DUKE ELLINGTON
SCHOOL OF THE ARTS
MODERNIZATION

Date: Start 9/16/2013

SIT/Community Issues Tracking List

SKYVIEW TERRACE

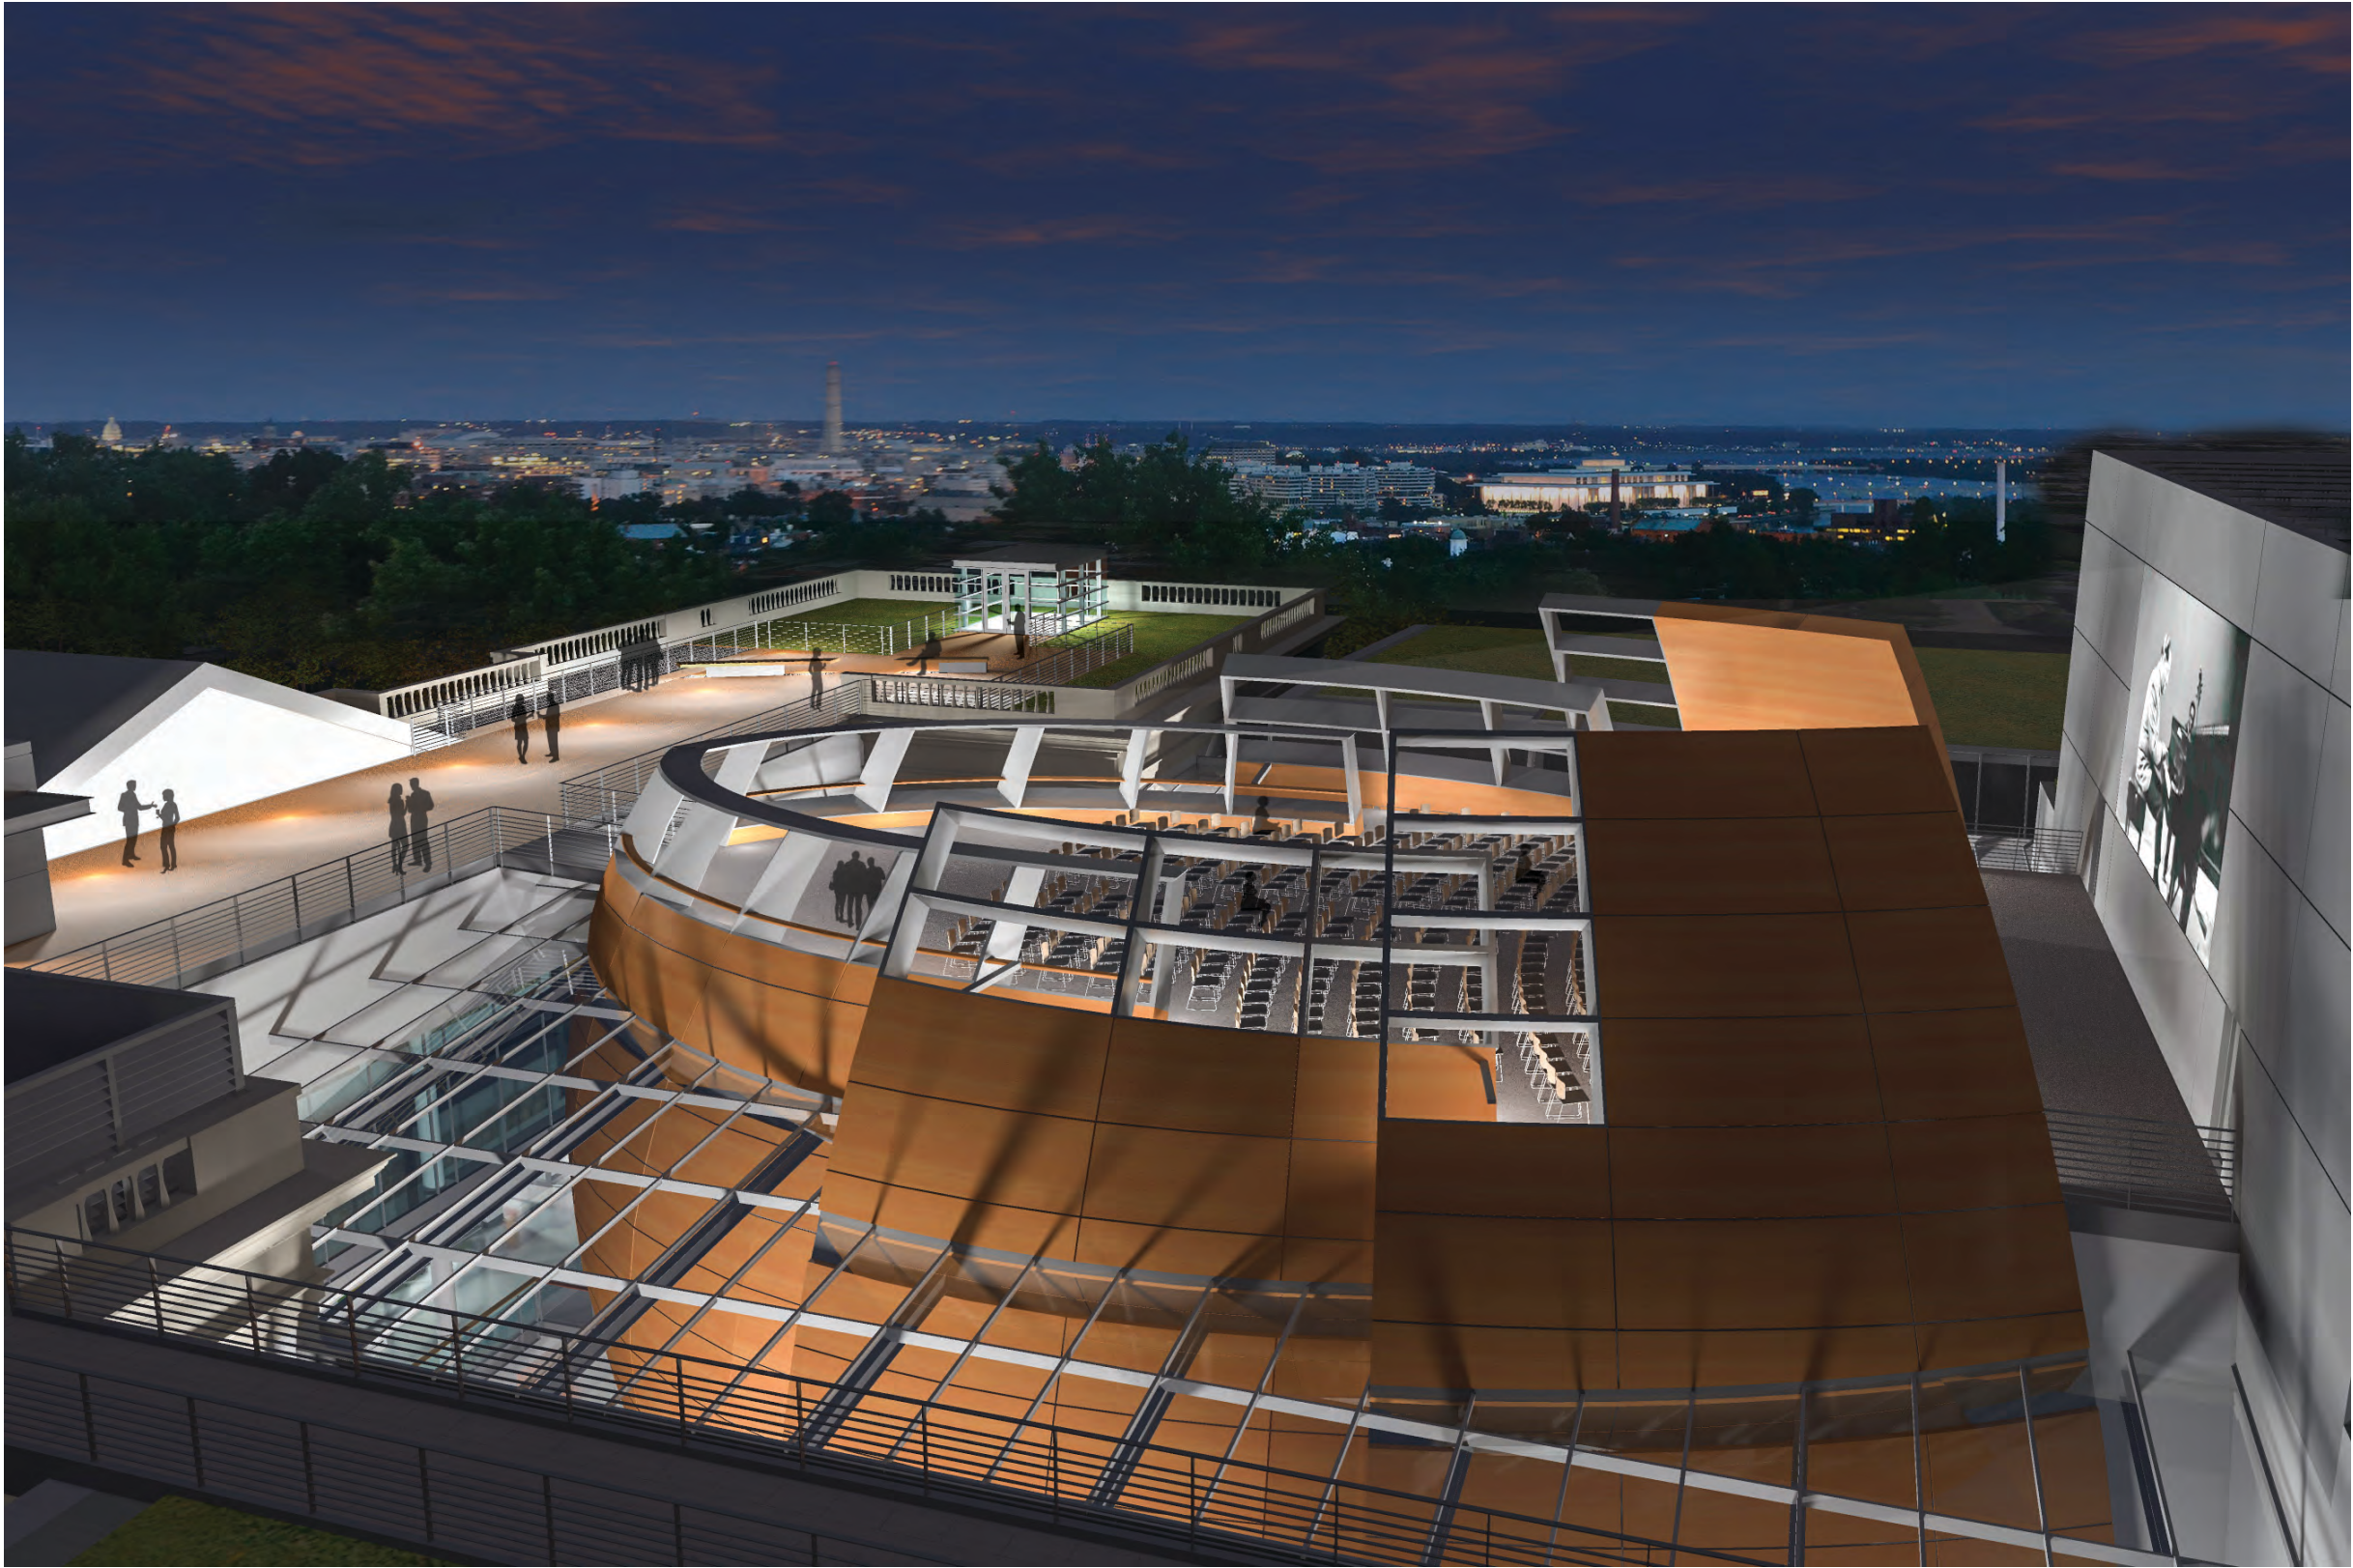
No.	Issue/Comment	SIT Source	Start Date	End Date	Response/Actions
1	Roof Terrace will create noise and visual disturbance to the community and should be re-considered.	Community	8/21/13		Skyview Terrace is considered a critical asset of the DESA program and will be used primarily for school classroom use. It is buried deep within the footprint of the 4 story building with at least 95 feet of roof area around all sides. A/E is currently underway with a sophisticated acoustic engineering study which will quantify and analyze the sound impact of the use of this space long the adjacent residential streets. It is anticipated the study will be complete within two weeks, the results of which will be made available to the community. A major outcome of this study will also be recommendations on ways to utilize the structure/enclosure that is designed around the sides of the venue to address sound and light migration. Additionally DESA is developing and will provide a defined program usage of this space outlining the predominantly in-house use, number of outside events, types of use related to noise generation/amplified sound and time limitations.
